# A303 Sparkford to Ilchester Dualling Scheme TR010036

## 7.7 Road Safety Audit

**ROAD SAFETY AUDIT**

## **Stage 1 Road Safety Audit**

Figure 4.1 : Proposed Camel Cross Link junction with the Link to B3151

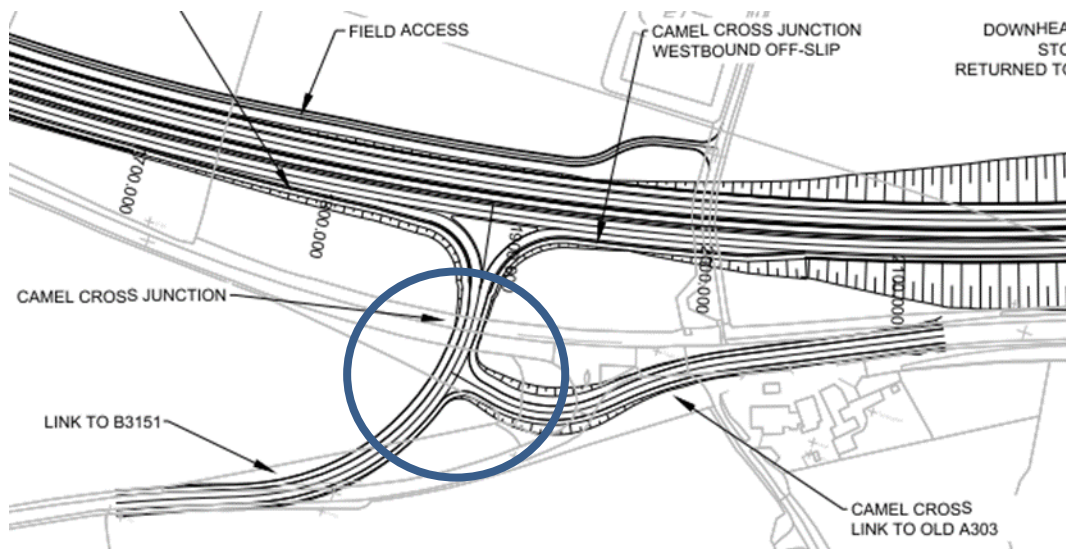
- 4.4.3 The Audit Team is concerned that the proximity of the B3151 / Camel Cross Link junction to the A303 westbound exit (to the north) will make it difficult for vehicles to turn in / out safely. Furthermore, SSD to the junction for traffic travelling eastbound on the B3151 may also be reduced because of the highway alignment on approach (a left-hand bend).
- 4.4.4 This could result in an increased risk of collisions between right-turning in / out traffic at the junction for Camel Cross Link.

- 4.4.5 It is recommended that the junction at B3151 / Camel Cross Link is relocated further south-west so as to provide improved visibility / SSD to the junction, in both directions. Typically, the desirable minimum SSD requirement is 120m for a design speed of 70kph (as specified in DMRB, TD9/93, Table 3).

- 4.4.6 The junction has been moved approximately 50m further south.
- 4.4.7 In addition, the layout design has been changed from a T Junction with priority given to traffic leaving / entering the A303, to a T Junction with priority given to B3151. The change in junction form is considered to change driver behaviour as they would be expecting to slow as they approach the give way line to the B3151 junction from the A303. Appropriate forward visibility is provided with verges widened at the junction to provide full visibility at the junction. Queuing off the A303 is not considered to be an issue due to the relatively low traffic flows.

Figure 4.2 Showing discontinued footway on the northern side of Steart Hill.

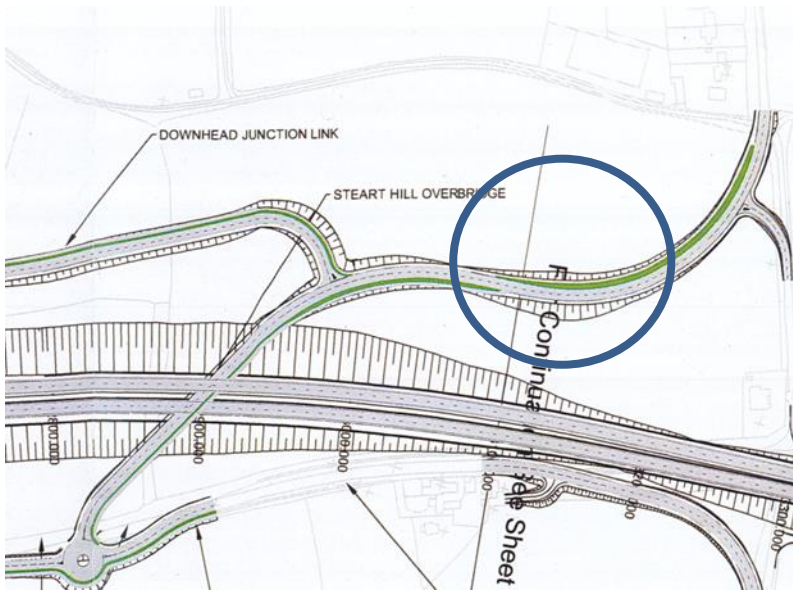
4.5.3 The Audit Team is concerned that this gap in footway provision on the northern side of Steart Hill will result in pedestrians walking in the verge or on the carriageway, increasing the risk of collisions with passing vehicles.

4.5.4 It is recommended that a continuous footway is provided between the Downhead Junction Link and Steart Hill, on the northern side.

4.5.5 The layout design has been updated to provide a continuous NMU route on Downhead Lane, Downhead junction Link and Steart Hill Link.

Figure 4.3 Showing Camel Hill Link at junction with Vale Farm Link.

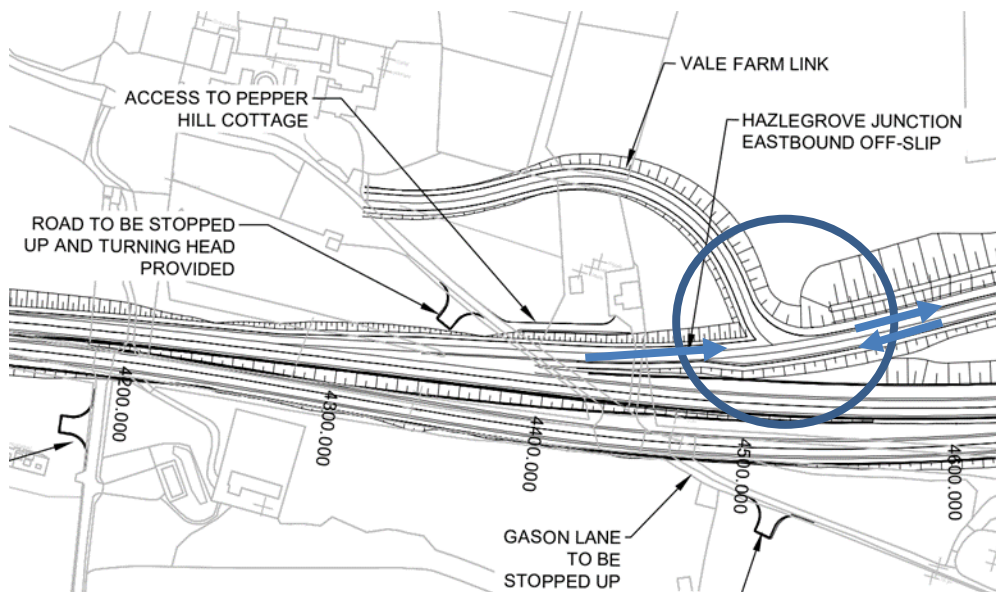
#### 4.6.2 The proposed priority junction at this location may result in the following road safety issues:

- Motorists approaching the junction from the A303 eastbound, may do so at high speeds, due to the long and straight alignment of the off-slip road. This has the potential to increase the risk of collisions, particularly at the new priority junction where slower vehicles may be turning into Vale Farm Link.

- It is unclear if left-turn manoeuvres into Vale Farm Link will be permitted. The Audit Team is concerned that if no deceleration lane is provided then vehicles slowing to carry out a left turn manoeuvre will be at risk of rear end shunt-type collisions with (potentially faster) traffic following behind.

- Motorists travelling westbound on Camel Hill Link (a two-way road) may not fully appreciate that access is prohibited beyond the Vale Farm Junction. Due to the alignment, there is a concern that vehicles will be able to join the A303 eastbound off slip, in the wrong direction, which is likely to result in head-on collisions.

- Drivers on the A303 eastbound off-slip may not anticipate oncoming (westbound) vehicles on Camel Hill Link, to the west of the Vale Farm Junction, particularly at night when only headlights can be seen at distance. This could result in sudden lane changing or braking manoeuvres increasing the late braking and / or loss of control collisions on the A303 eastbound off slip.

#### 4.6.3 It is recommended that the form and function of the junction at Camel Hill Link / Vale Farm is reviewed.

4.6.4 The Audit Team is of the opinion that a roundabout may better serve traffic movements at this location and could address many of the issues highlighted (including the potential for high eastbound approach speeds and conflicts from turning movements).

4.6.6 The layout design has been changed from a T Junction to a roundabout (see updated drawings in appendix B).

Figure 4.4 Showing proposed (unsegregated) two-way section on the northern arm.

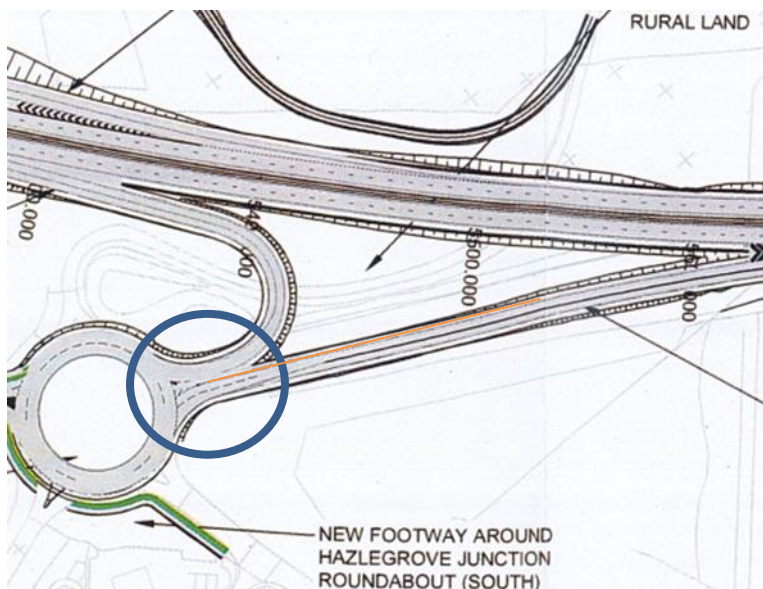
4.7.2 This two-way arrangement could manifest in collisions due to:

- Vehicles entering the wrong side of the carriageway after exiting the roundabout, and / or;

- Increased risk of vehicles entering the A303 off-slip road in the wrong direction and potentially joining the A303 in the wrong direction.
- Furthermore, failure to provide appropriate segregation between the traffic streams (such as a constructed median / safety fence) may allow vehicles to carry out u-turning at this location, increasing the risk of collisions.

4.7.3 It is recommended that suitable segregation between the traffic streams is provided at this location. This may include realigning the carriageway(s) to increase segregation.

4.7.4 The layout design will include a kerbed splitter island.

Figure 4.5 Junction arrangement at Hazlegrove Link / Hazlegrove House Access

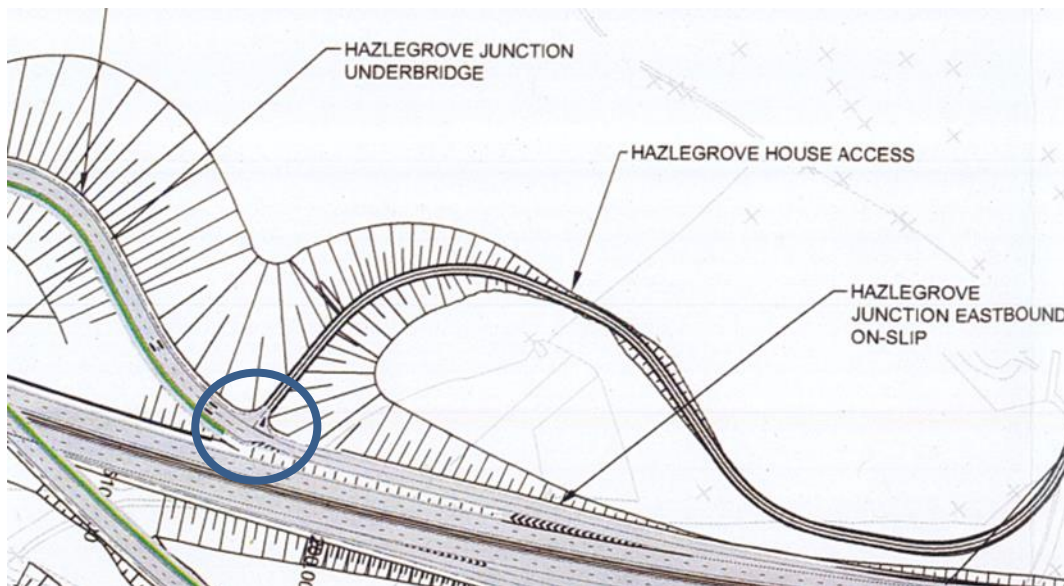
4.8.2 This could lead to an increased risk of collisions, particularly as there may be a tendency for higher eastbound traffic speeds, accelerating to join the A303 eastbound.

4.8.3 It is recommended that the visibility splay between vehicles on Hazlegrove Link (eastbound) and those waiting / attempting to turn right (westbound) from the access road at the junction are calculated and provided.

4.8.4 This includes providing sufficient SSD on approach to the junction.

4.8.5 Access to Hazlegrove House has been removed from Hazlegrove Junction eastbound on-slip layout design. An alternative private means of access to Hazlegrove House has been provided between the roundabout located to the western extent of the 690m long Camel Hill Link and Hazlegrove Junction eastbound on-slip. Desirable minimum sight stopping distance is for achieved for both junctions. Through this provision, both Hazlegrove House access and Hazlegrove eastbound on-slip have dedicated junctions/access located 150m apart. This has deconflicted local traffic wishing to access/egress Hazlegrove House with that of vehicles wishing to join/re-join the eastbound A303.

**Figure 1:** Proposed Camel Cross Link junction with the Link to B3151

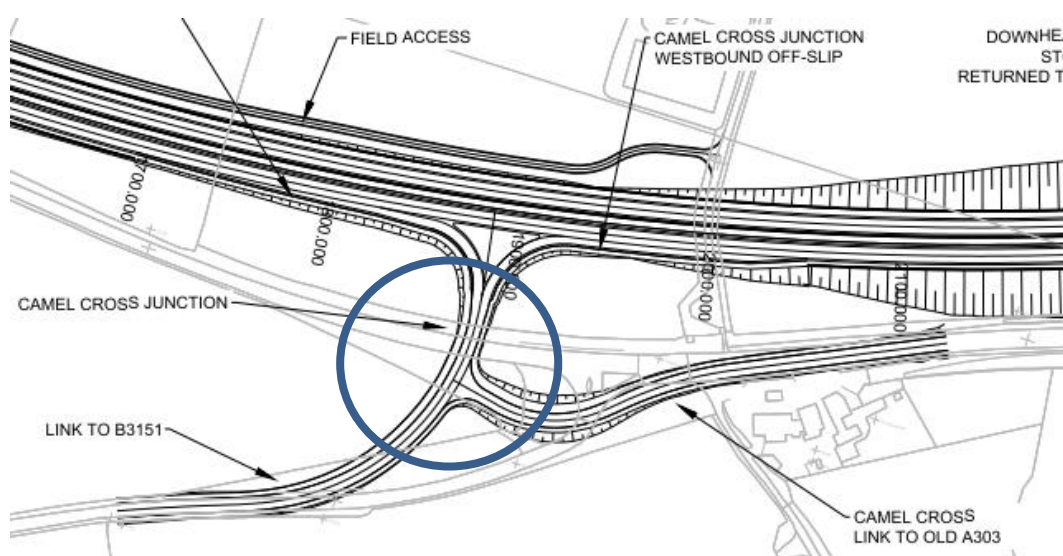
The Audit Team is concerned that the proximity of the B3151 / Camel Cross Link junction to the A303 westbound exit (to the north) will make it difficult for vehicles to turn in / out safely. Furthermore, SSD to the junction for traffic travelling eastbound on the B3151 may also be reduced because of the highway alignment on approach (a left-hand bend).

This could result in an increased risk of collisions between right-turning in / out traffic at the junction for Camel Cross Link.

It is recommended that the junction at B3151 / Camel Cross Link is relocated further south-west so as to provide improved visibility / SSD to the junction, in both directions. Typically, the desirable minimum SSD requirement is 120m for a design speed of 70kph (as specified in DMRB TD9/93 Table 3).

**Figure 2:** Showing discontinued footway on the northern side of Steart Hill.

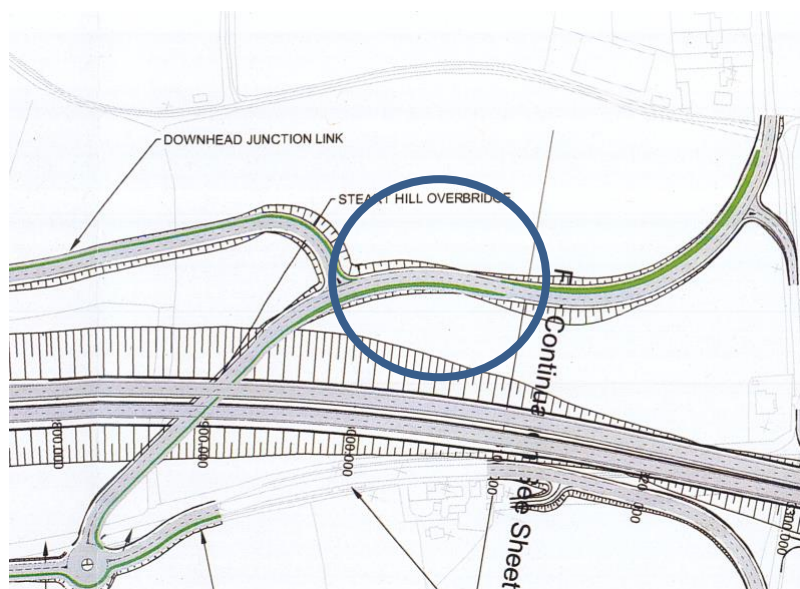
The Audit Team is concerned that this gap in footway provision on the northern side of Steart Hill will result in pedestrians walking in the verge or on the carriageway, increasing the risk of collisions with passing vehicles.

It is recommended that a continuous footway is provided between the Downhead Junction Link and Steart Hill, on the northern side.

**Figure 3:** Showing Camel Hill Link at junction with Vale Farm Link.

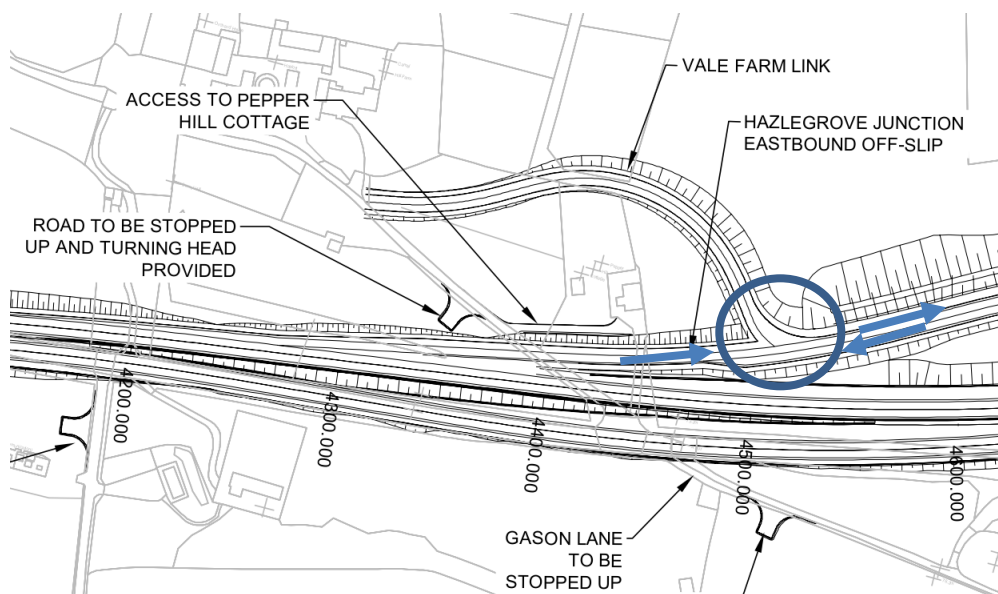
The proposed priority junction at this location may result in the following road safety issues:

- Motorists approaching the junction from the A303 eastbound, may do so at high speeds, due to the long and straight alignment of the off-slip road. This has the potential to increase the risk of collisions, particularly at the new priority junction where slower vehicles may be turning into Vale Farm Link.

**Figure 4:** Showing proposed (unsegregated) two-way section on the northern arm.

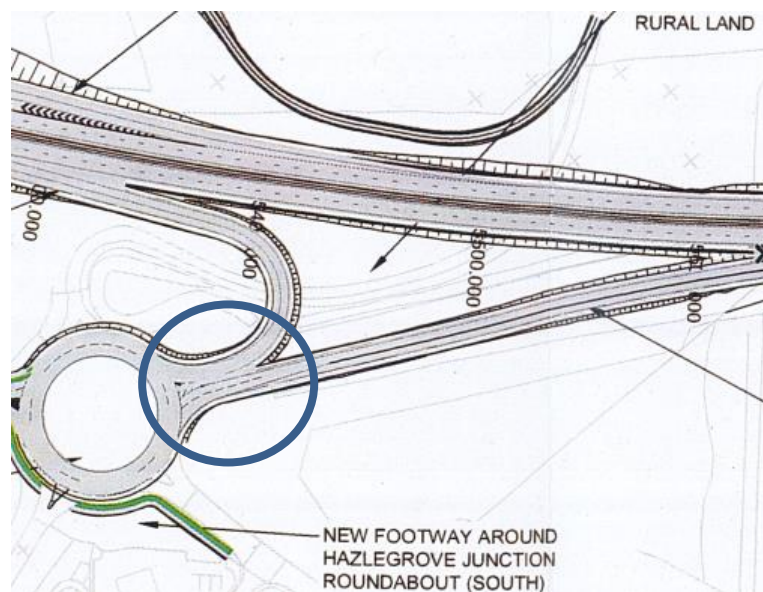
Furthermore, failure to provide appropriate segregation between the traffic streams (such as a constructed median / safety fence) may allow vehicles to carry out u-turning at this location, increasing the risk of collisions.

**Figure 5:** Junction arrangement at Hazelgrove Link / Hazelgrove House Access

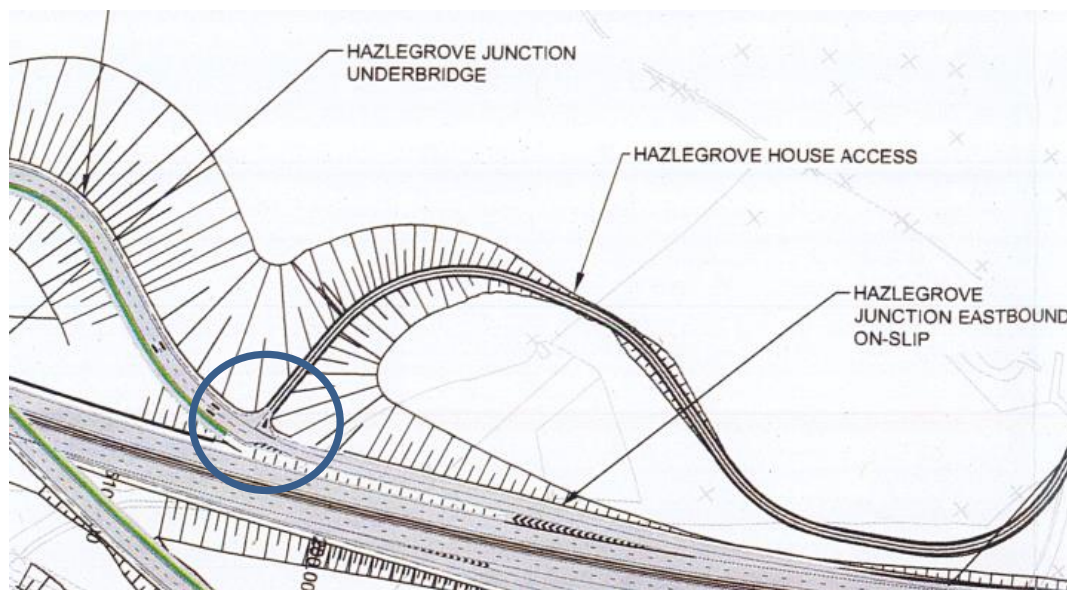
On Hazlegrove Link, at its junction the Hazlegrove House Access, the alignment of the eastbound approach is such that it may impact on inter-visibility between vehicles manoeuvring at the junction.
